APPLICATION FOR PERMISSION

檔案編號: A/YL-SK/307

檔案編號: A/YL-ST/307

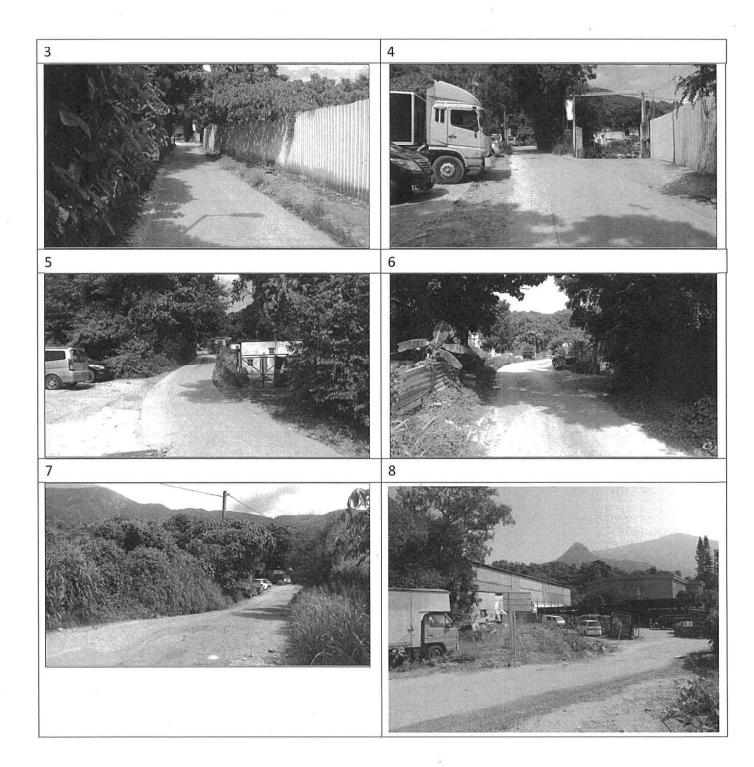
1. The appliant should provide the trip generation and attraction due to the development and assess the traffic impact to KAM TIN Road and the local access with consideration of existing traffic at the local access.

申請地點的車輛流量預算

A/ YL-SK/307 的車輛流量預算							
星期一至六							
	貨	 置車	貨	車	私多	京車	
No.	入	出	入	出	入	出	每小時車輛
							出入次數
09:00 - 10:00	0	0	0	0	0	0	0
10:00 - 11:00	0	0	2	0	0	0	2
11:00 - 12:00	0	0	0	2	0	0	2
12:00 - 13:00	0	0	0	0	0	0	0
13:00 - 14:00	0	0	0	0	0	0	0
14:00 - 15:00	0	0	0	0	0	0	0
15:00 - 16:00	0	0	2	O.	0	. 0	2
16:00 - 17:00	0	0	0	2	0	0	2
17:00 - 18:00	0	0	0	0	0	0	0
18:00 - 19:00	0	0	0	0	0 -	0	0

申請地點開放時間,為星期一至星期六,每日早上八時至晚上八時,星期日及公眾假期休息。通常產生車輛流量時間為早上十時至十二時及下午三時至五時。由於進出申請地點的車輛數目極為穩定,只有兩輛 5.5 噸輕型貨車,故申請地點的車輛流量都可在預計之內。

申請人每星期會特定一天作物流貨運日,分上下午進行。會使用輕型貨車每周送貨或進貨兩次,一個月約有八次運輸工作,約 16 駕次汽車流量,車流微不足道。申請地點的貯物倉庫內設置兩個上落貨車位。不會出現在申請地點或其他地方胡亂泊車的情況。申請地點亦不會有訪客,故此不設訪客泊車位。此申請不會有超過 5.5 噸的車輛出入申請地點,或使用申請地點內設的泊車位。

場地大綱圖(4/6/2021)

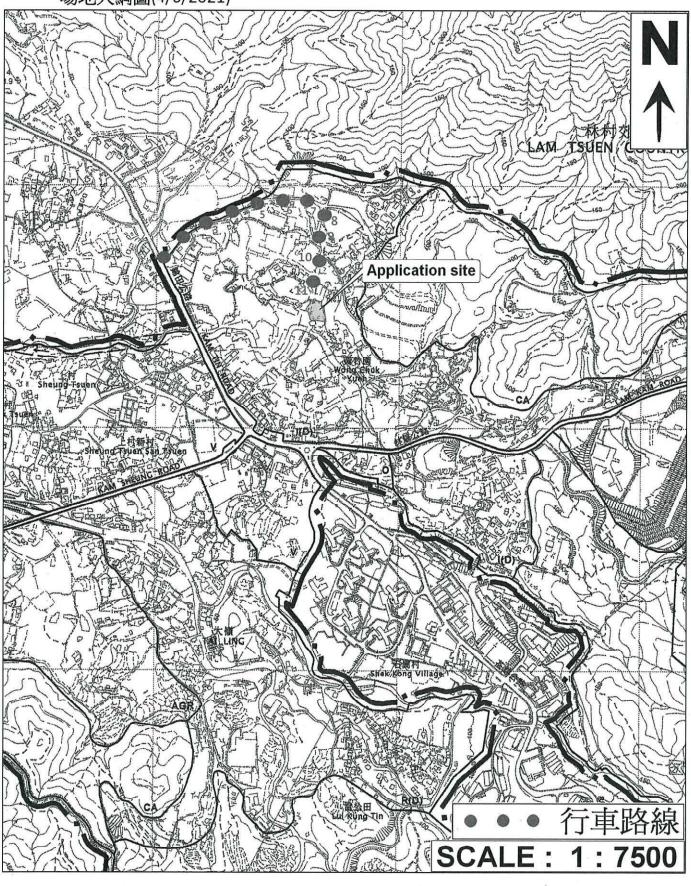
2. The appliant should demonstrate the smooth manoeuvring of vechicles to / form KAM TIN Road.

申請地點與錦田公路之間的行車通道,即磚窯路及連接村路。磚窯路平均闊度都有4米以上,已鋪設成混凝土路面。而且沿路有不少避車位置,相信行車通道可供5.5噸小型貨車安全使用。可參考:新修正的場地大綱圖(4/6/2021)及實況照片。

場地設計圖 31/5/2021

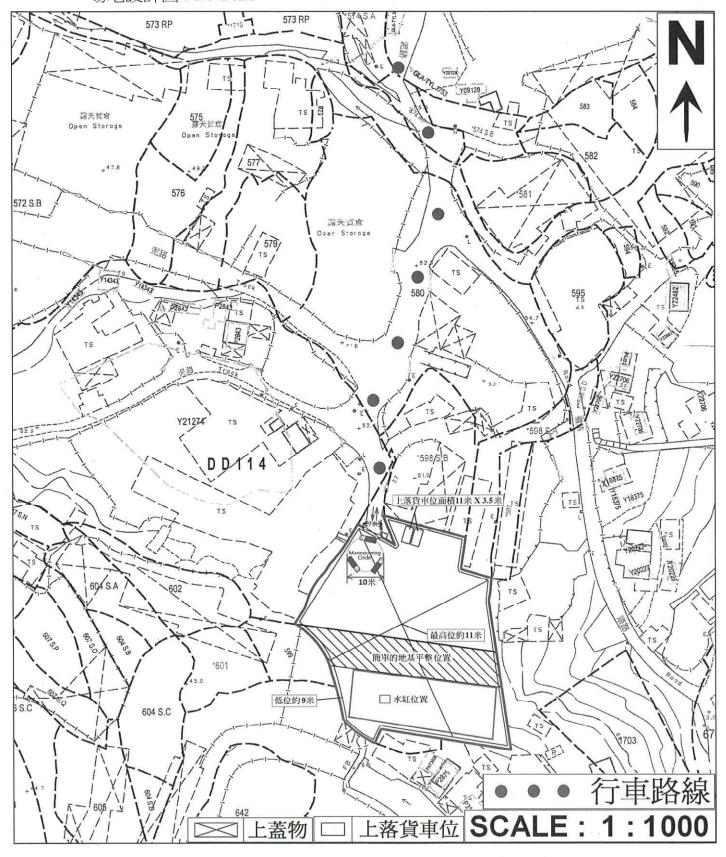
2. 規劃署又指,申請人在補充資料中提到,申請發展不會涉及土地 的填埋或挖掘。規劃署在現場觀察到該場地的地形是不平坦的, 最低點和最高點之間相差幾米。具體而言,該站點的東部涉及一 個斜坡。故此必須澄清,擬議的開發項目是否涉及土地的填埋或 開挖,以形成平坦的地面或平台,是否涉及任何邊坡工程(例 如,切割邊坡,修建擋土牆)。

3. 由於申請地點的地形不平坦,請指出從哪一點開始可參考的最大 建築物高度為 11m。

申請地點地形不平坦,南面部份位置地勢較低。申請人會在接近中心位置,斜度不明顯的部份,進行簡單的地基平整;而接近南面部份地勢較低的位置,會因利成便,將該部份低位預留作建造消防水缸。建成消防水缸後,消防儲水缸等於藏於地底,而該部份土地(消防水缸外圍),會與其他部份平整同一地面水平。消防水缸體積為2米 X 400 平方米 = 800 立方米。(可參閱:新修正場地設計圖 31/5/2021)

申請地點擬建一個以金屬及混凝土搭建的密封式構築物(貯物倉庫)。構築物金字頂,樓高一層,最高位約 11 米(即金字頂最高位至 MPD 的高度),低位約 9 米(即金字頂低位至 MPD 的高度)。最大建築物高度為 11m,是指現時北面地勢水平最高的地面位置計起。(可參閱:新修正場地設計圖 31/5/2021)
